MIDLAND PROJECT
DOCKET NO 50-329, 50-330
RESPONSE TO 10 CFR 50.54 REQUEST
ON DESIGN ADEQUACY OF B&W SYSTEMS
FILE: 0485.19 SERIAL: 8563

Enclosed are ten (10) copies of Consumers Power Company's response to your supplemental 10 CFR 50.54(f) request dated March 7, 1980 regarding B&W System Sensitivity.

RESPONSE TO 10 CFR 50.54(f)
SUPPLEMENT 1

FIGURE F.1-1

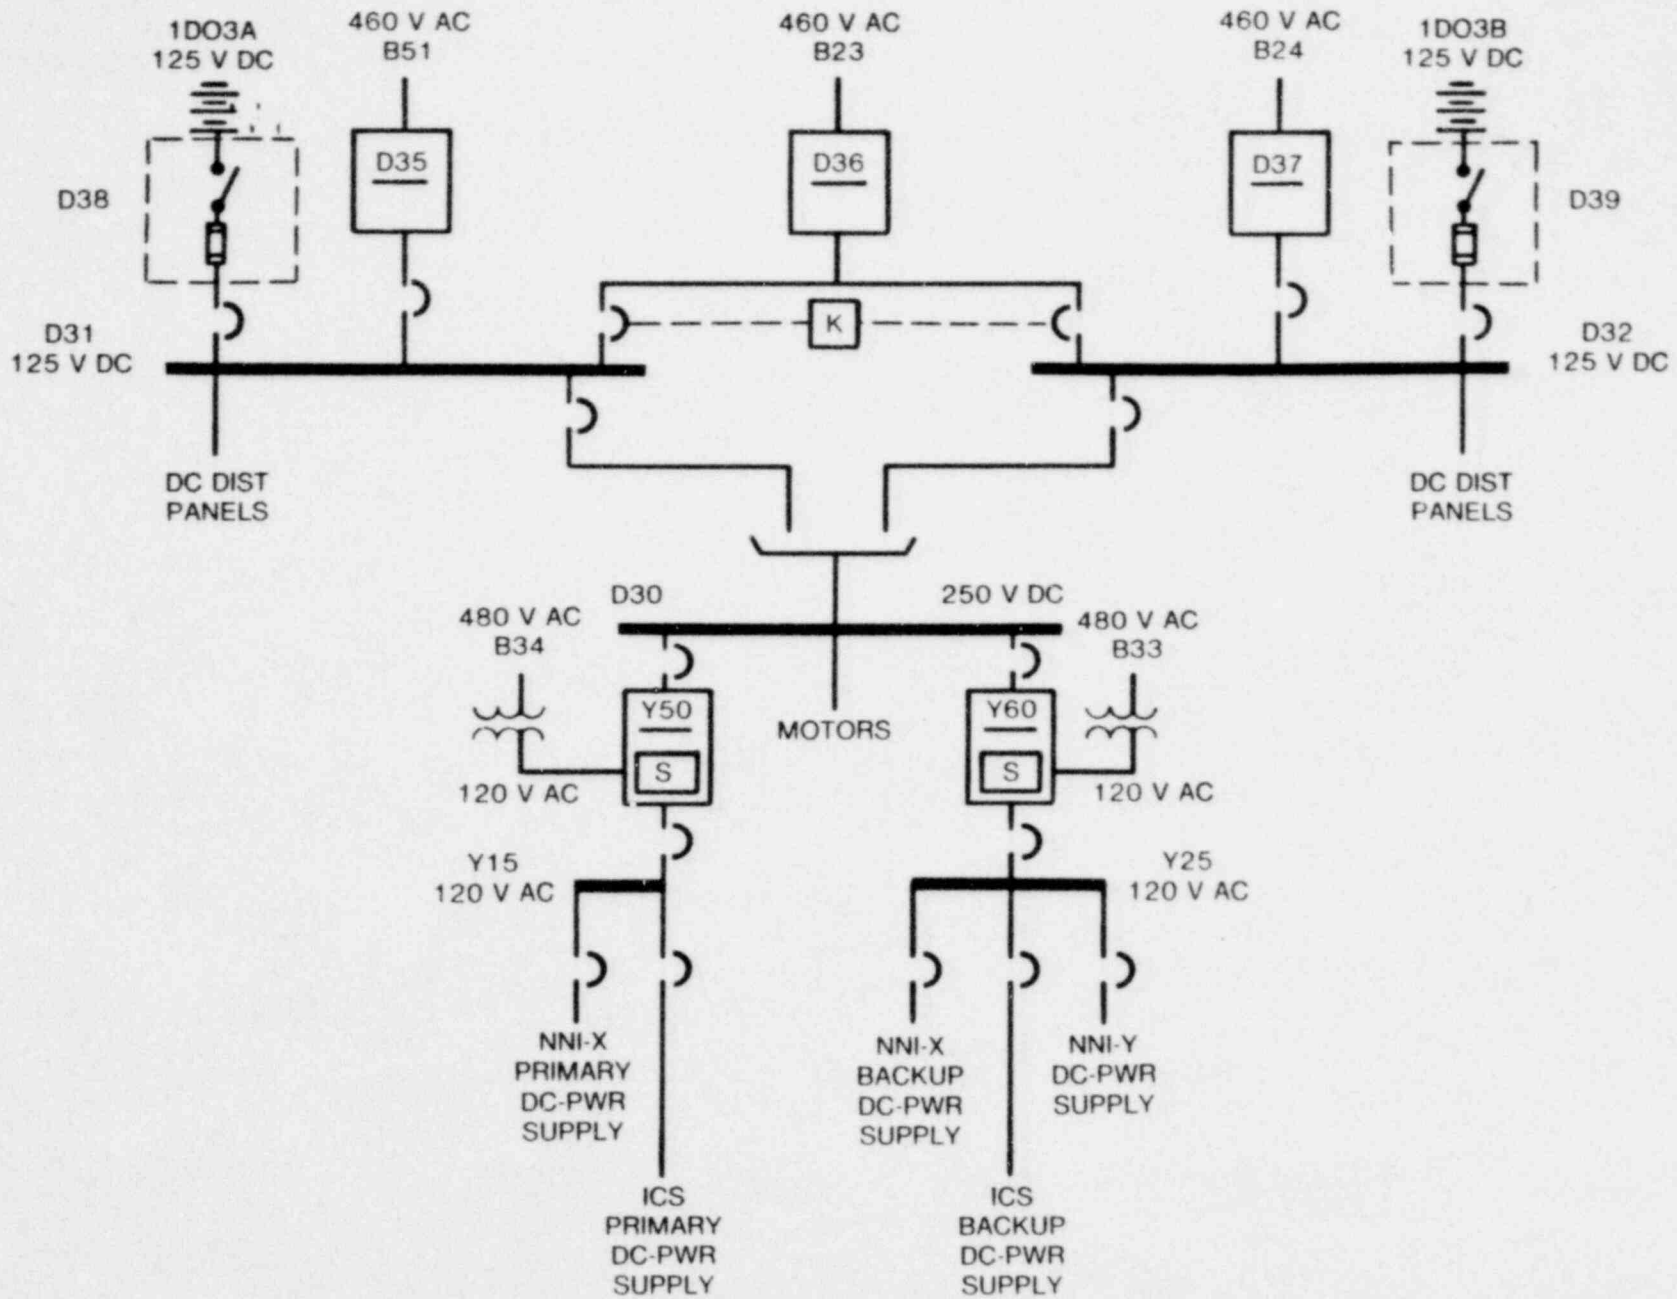
Your discussion in Appendix F of the pre-TMI-2 changes for Midland states that newer control systems hardware (non-nuclear instrumentation [NNI]/ integrated control system [ICS]) using dual auctioneered power supplies for logic modules rather than individual power supplies are being used.

- a. For this modification, provide the logic and/or your failure mode and effects analysis that shows how systems will respond to failure in the power supply and input parameters. Also provide your design criteria for the ICS with respect to these types of failures. Information in the FSAR may be referenced or supplemented as appropriate for this response.

- b. The FMEA of the ICS described in the response to Part a, above, discusses the reliability of the 820 control system design. The nonnuclear instrumentation (NNI) utilizes the same design concept as the ICS; therefore, reliability of the NNI hardware is expected to be equivalent to that of the ICS. This reliability is expected to minimize the frequency of ICS/NNI internal component failures which could result in plant transients. The arrangement of the external power sources to the NNI and ICS is shown in Figure F.1.a-1 and is described in FSAR Subsections 8.3.1.1.6 and 8.3.2.1. As shown, the ICS is supplied by two separate 120 V ac battery-backed power sources. These sources power individual 24 V dc power supplies whose output is auctioneered. Also supplied is a 120 V ac bus within the ICS cabinet which is equipped with an automatic bus transfer switch that provides access to both external battery-backed 120 V ac sources. This is an extremely reliable power supply arrangement in that loss of either external power source will not result in a loss of ICS power.

FIGURE F.3-1
RCS RESPONSE TO REACTOR TRIP

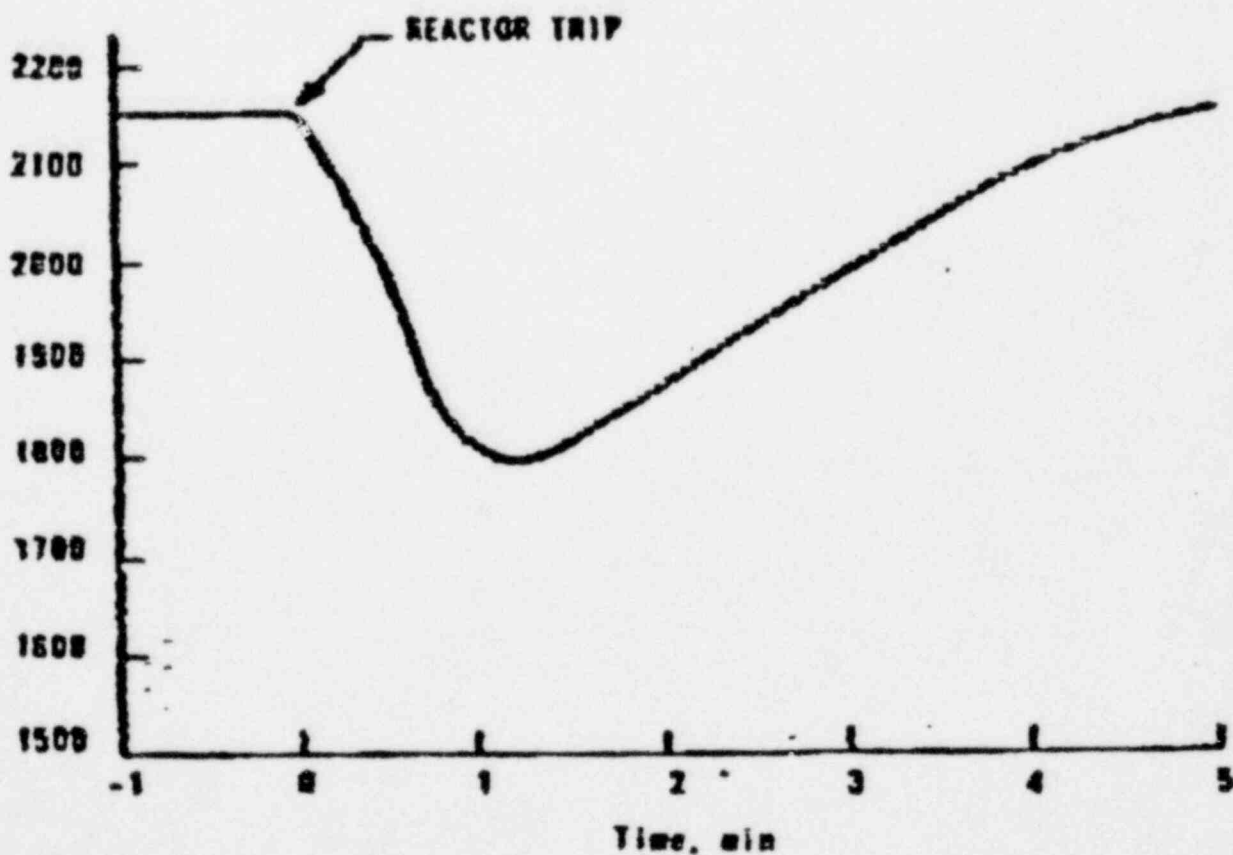
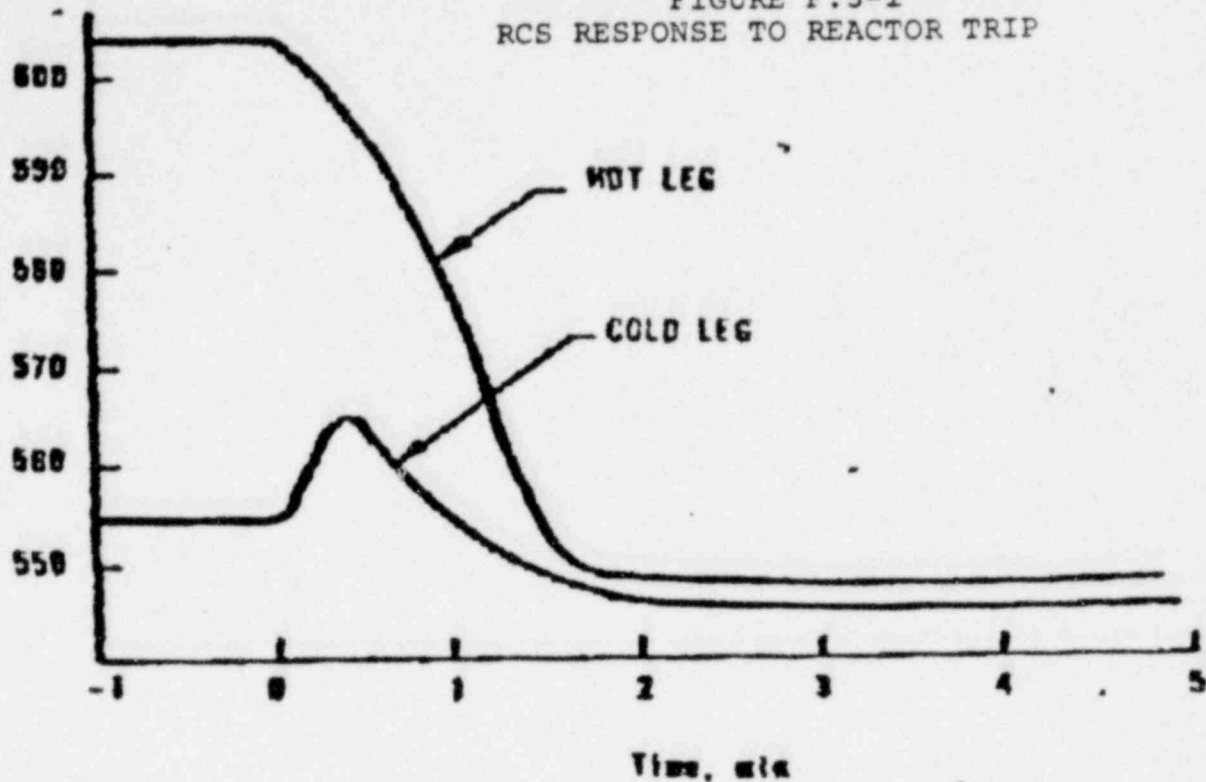
Experience at operating B&W plants have indicated that the dynamics associated with main feedwater termination and steam generator pressure control following a reactor trip can lead to overcooling of the primary system. Discuss your criteria and the adequacy of your existing and proposed design features and changes to preclude this overcooling situation.

Figure F.3-1 illustrates reactor coolant (RC) temperature and pressure following a reactor trip with proper feedwater flow and steam pressure control. The rapid decrease in reactor power causes RC temperature to decrease; the resultant RC contraction causes a decrease in RC liquid volume and pressure. The RC cold leg temperature reaches an equilibrium value equal to the saturation temperature of the secondary side steam pressure (546F at 1,000 psig), and the RC pressure is restored to 2,155 psig due to the normal makeup flow which accommodates the RC contraction that occurs as the average RC temperature drops from 579F to 546F.

Overcooling of the primary system can occur if excessive MFW is added to the steam generator (due to improper feedwater valve control), or steam pressure falls significantly below 1,000 psig (due to improper steam relief valve operation). Experience at a Babcock & Wilcox (B&W) operating plant has demonstrated that such overcooling is a moderate frequency event which is safely mitigated by the action of the high-pressure injection (HPI) system. The operating data shows that there have been 24 reactor trip events followed by an overcooling which caused the RC pressure to fall below 1,600 psig and/or caused the RC temperature to exceed a 100F in 1 hour cooldown rate. The 1,600 psig value of RC pressure approximates the setpoint for automatic initiation of the HPI system (1,500 psig for Midland), and should be avoided for anticipated transients to minimize challenge to the safety systems. The 100F in 1 hour cooldown

FIGURE F 10-1
SIMPLIFIED DIAGRAM
MIDLAND PLANT UNITS 1 AND 2
AUXILIARY FEEDWATER SYSTEM
DESIGN

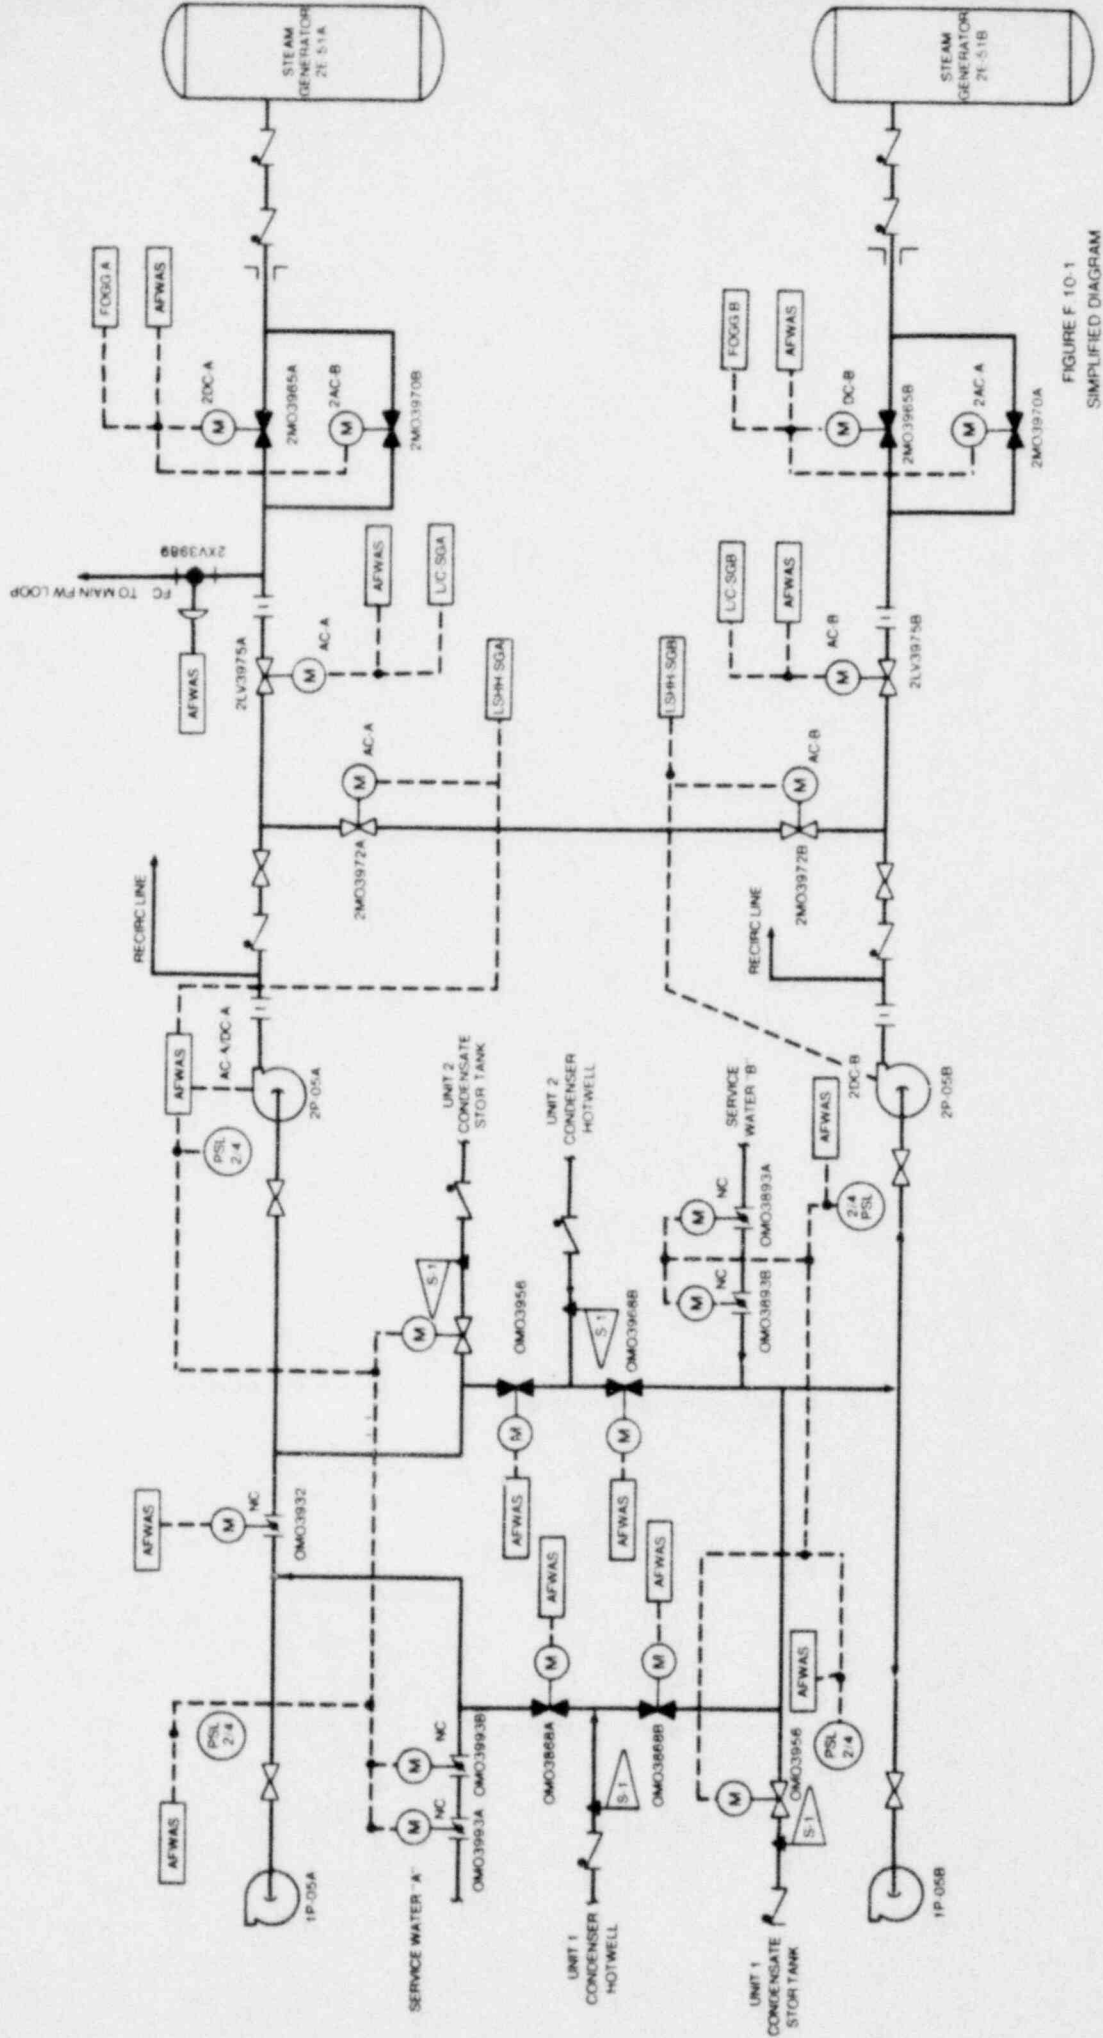
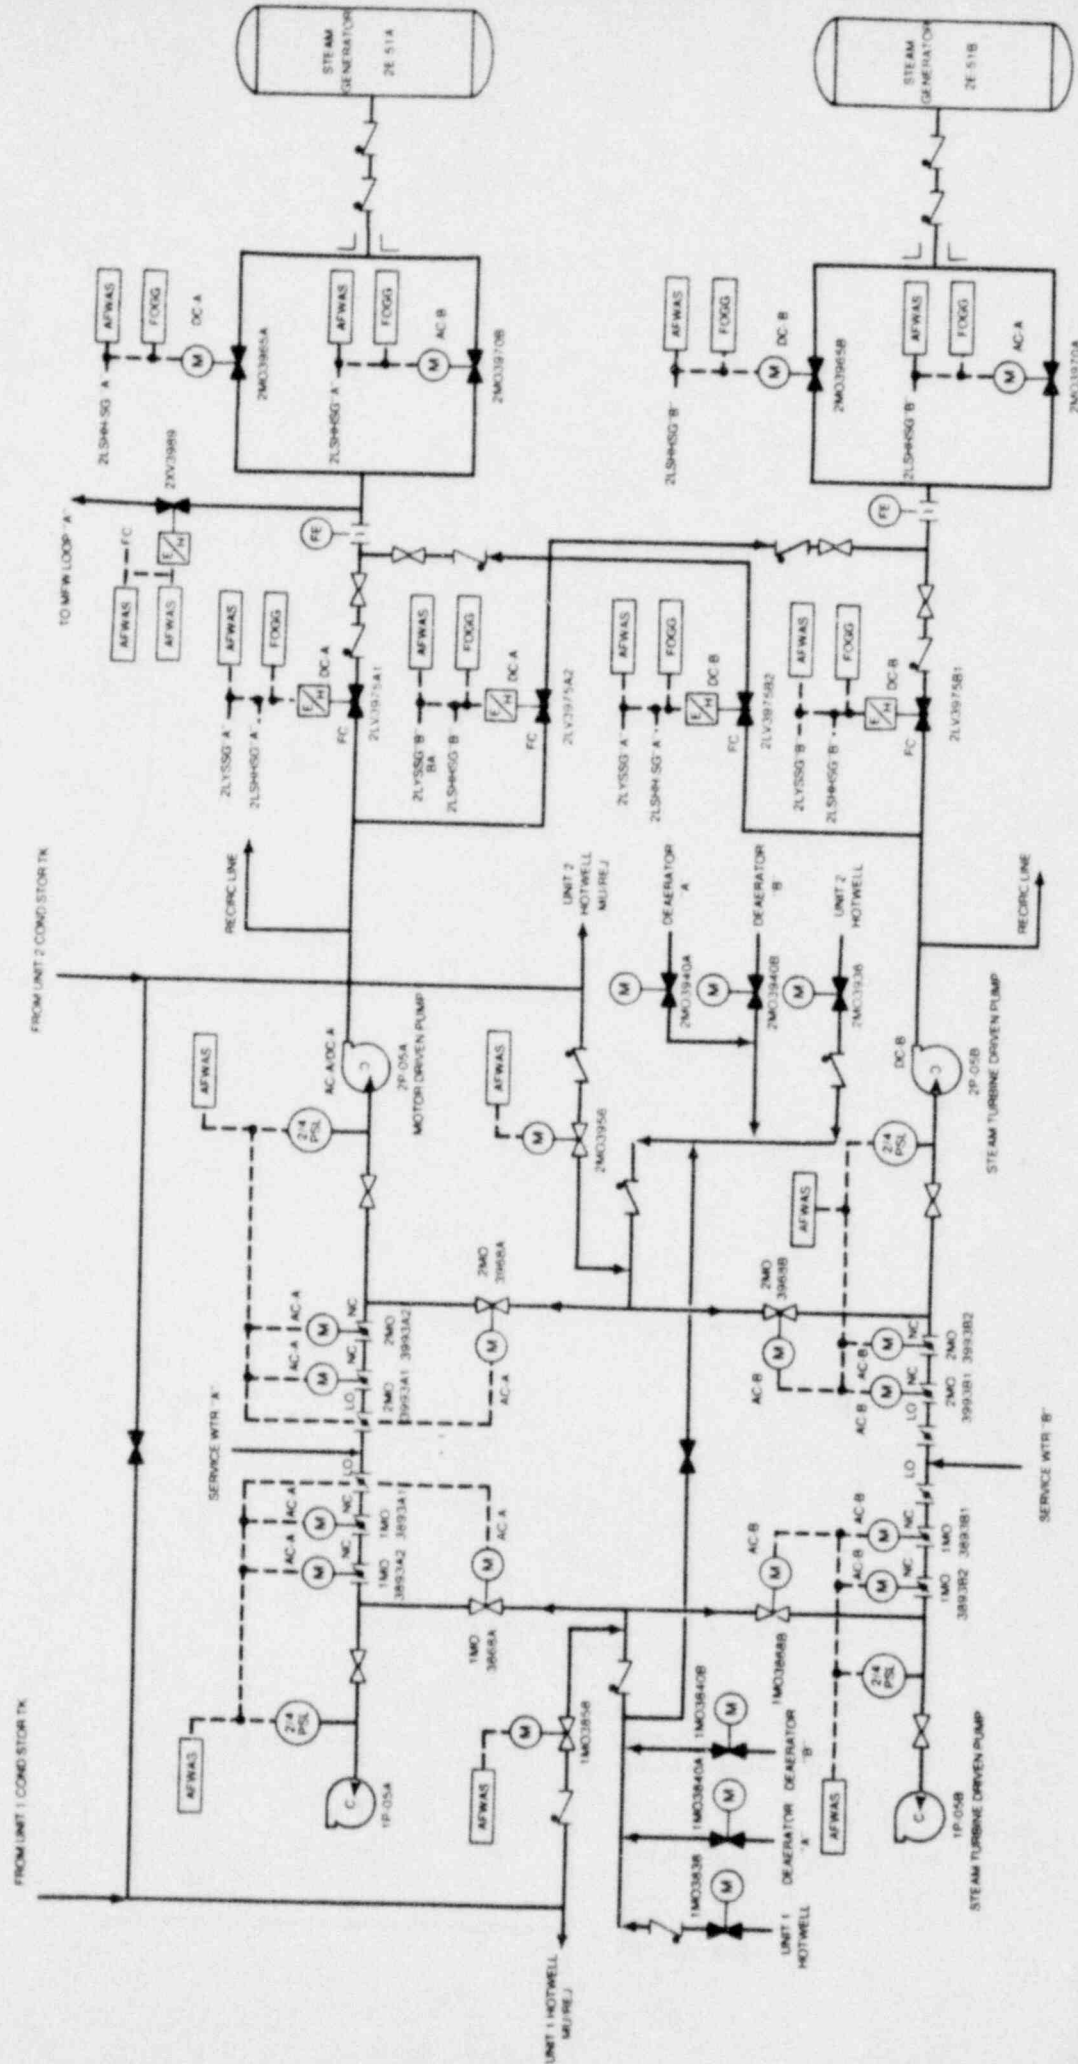
- a. Modification of the AFW pump suction piping from one interconnected system for both Midland units to two systems operating independently to supply AFW to each unit, and
- b. The addition of redundant flowpaths from the discharge of each AFW pump to each steam generator.

Provide a simplified diagram illustrating the previous and revised configurations. Include a table denoting valve positions during normal and abnormal operating conditions. Specify your schedule for completion of the details of the revised Midland AFW design.

Figures F.10-1 and F.10-2 illustrate the previous (current) design and planned revised design, respectively, for both the suction piping and the discharge piping. The detailed control design and analysis is incomplete at this time; however, Figure F.10-2 indicates the control parameters planned to be used in the design.

Detailed design of the revised auxiliary feedwater system is expected to be essentially complete by August 1980. FSAR updating is anticipated at that time.
